# CODE CHANGE PROPOSAL FORM

Topic of proposal: Adult Changing Facilities

Code or rule section to be changed: IBC and A117.1

## Adult Changing Stations

**FIGURE 613.4.4**  
**SIDE AND END MANEUVERING CLEARANCES AT THE CHANGING SURFACE OF THE ASSISTIVE TABLE**

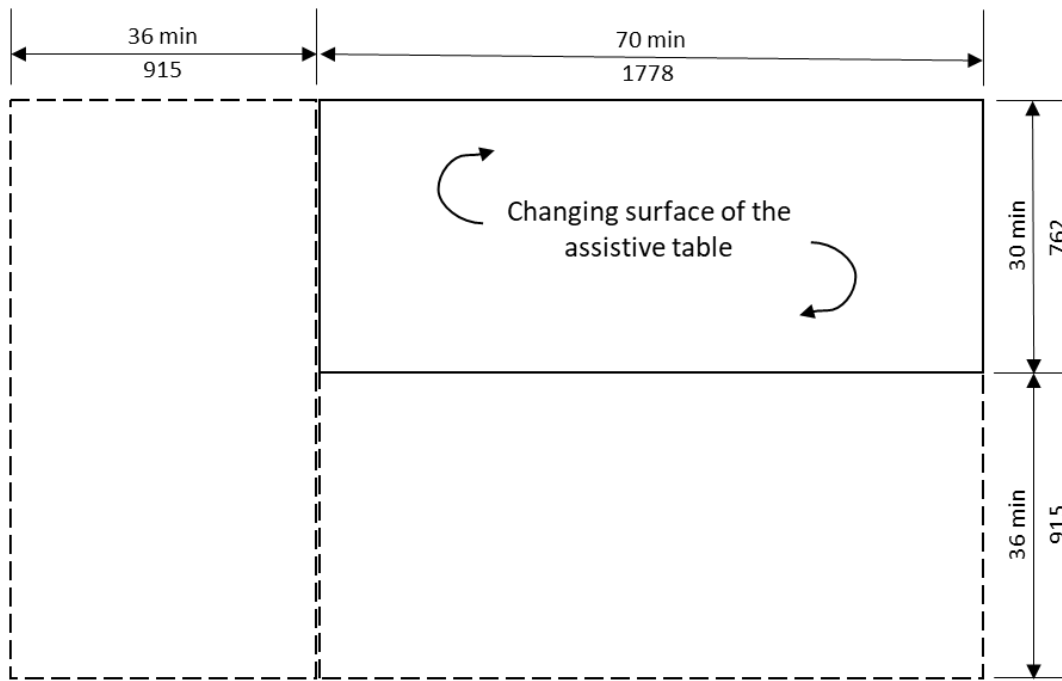
**613.4.4 Maneuvering clearances.** Maneuvering clearances at the changing surface of the assistive table shall complying with Sections 613.4.4.1 and 613.4.4.2. ~~shall be provided adjacent to the changing surface;~~ Such maneuvering clearance shall be measured when the changing surface is in the operational position.

**613.4.4.1 Side maneuvering clearance.** A side maneuvering clearance 36-inch (914mm) ~~deep~~ minimum in depth ~~side-clearance~~ shall be provided along the open long side of the changing surface.

**Exception:** In the raised position, the side rail shall be permitted to overlap the side maneuvering clearance.

**613.4.4.2 End maneuvering clearance.** An end maneuvering clearance 36-inch (914mm) ~~wide~~ minimum in width ~~end-clearance~~ shall be provided along the depth of one end of the changing surface. The ~~width~~ depth of the end maneuvering clearance shall extend the depth of the changing surface and the side maneuvering clearance.

1. An end maneuvering clearance 24-inch (610mm) ~~wide~~ minimum in width ~~end-clearance~~ shall be permitted where a clear floor space complying with Section 305.3 is provided within the room beyond the maneuvering clearances for the changing surface.
2. Where installed in locations specified in Section 613.2.2, end maneuvering clearances complying with Section 613.4.4.2 are not required.
